HISTORIC AND DESIGN REVIEW COMMISSION

Agenda Item No: 13

HDRC CASE NO: 2015-290
ADDRESS: 521 MADISON ST
LEGAL DESCRIPTION: NCB 749 BLK 8 LOT 4 EXC N 7.13 FT & LOT SW IRR 4.39 FT OF 3
ZONING: RM4 H HS RIO-4
CITY COUNCIL DIST.: 1
DISTRICT: King William Historic District
LANDMARK: Devine, Thomas N - House
APPLICANT: Daniel Sexton/Buffalo Contracting Services LLC
OWNER: Deng Hong
TYPE OF WORK: Exterior modifications
REQUEST:

**Historic and Design Review Commission
Design Review Committee
Report & Recommendation**

REAR ELEVATION
SCALE: 1/4"=1'-0"

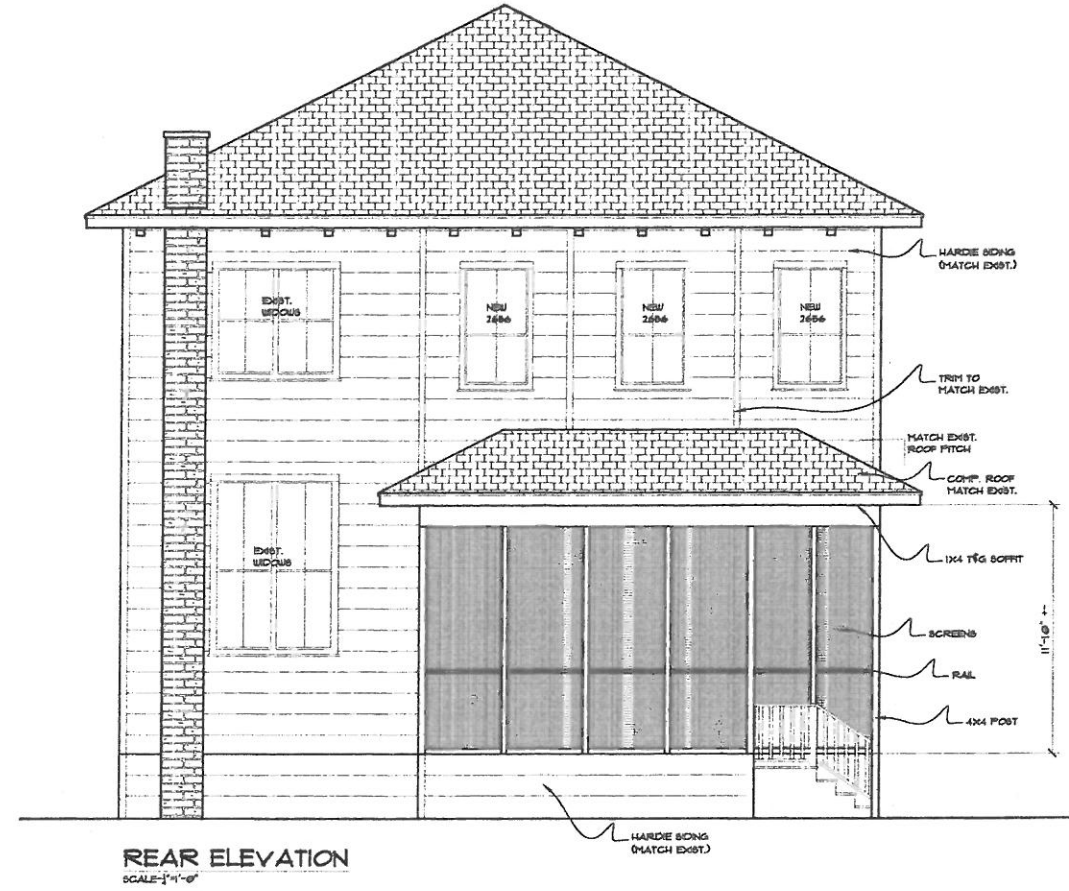
- g. The structure currently features a rear second level balcony. The applicant has proposed to enclose this balcony, maintaining the original footprint, install three windows in three bays that represent the previous columns grid featured in exiting second level balcony. Staff finds that the applicant's proposal is appropriate and consistent with the Guidelines for Exterior Maintenance and Alterations 7.B.ii., architecturally conveying that the space was previously used as a balcony.

COMMENTS/CONCERNS: MG: PROPOSED NEW DESIGN OF UPPER
BALCONY ENCLOSURE IS APPROPRIATE.

NEW PLAN
SCALE: 1/4"=1'-0"

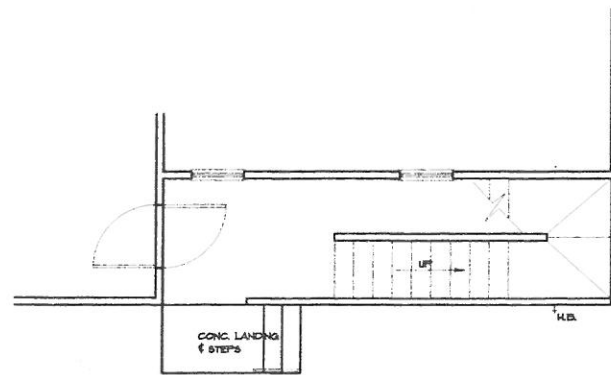
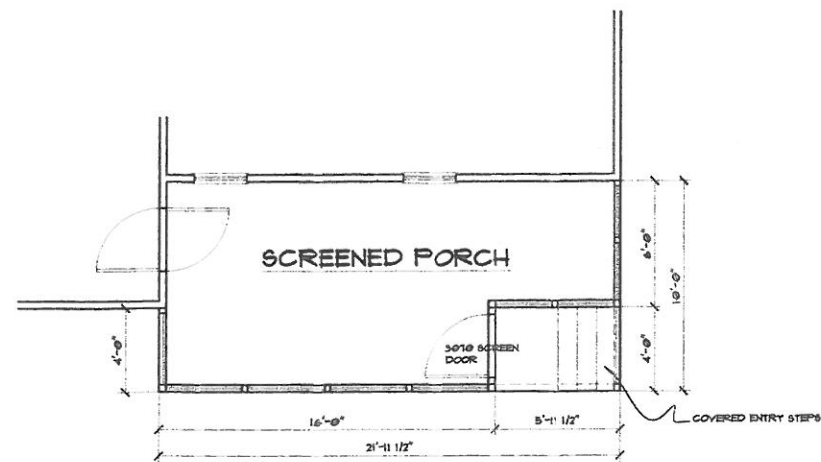
- c. The applicant has proposed to extend the porch at the lower level by an additional four feet in width and sixteen feet in length and relocate the existing stairs from the rear to the side by the driveway. The Guidelines for Additions 1.A. states that residential additions should be sited at the side or rear of the primary historic structure whenever possible, that views of the addition should be limited from the public right of way and that additions should be designed to be in keeping with the historic context of the block all while featuring a transition between the original structure and the addition. The applicant's proposal is consistent with the Guidelines.

- d. In regards to scale, massing and form, residential additions should be designed to be subordinate to the principal façade of the original structure, should feature a footprint that responds to the size of the lot and should feature a height that is consistent with the original structure. The applicant has designed the addition in a modest form

regarding detailing and has designed it at 64 square feet. This is consistent with the Guidelines for Additions 1.B.
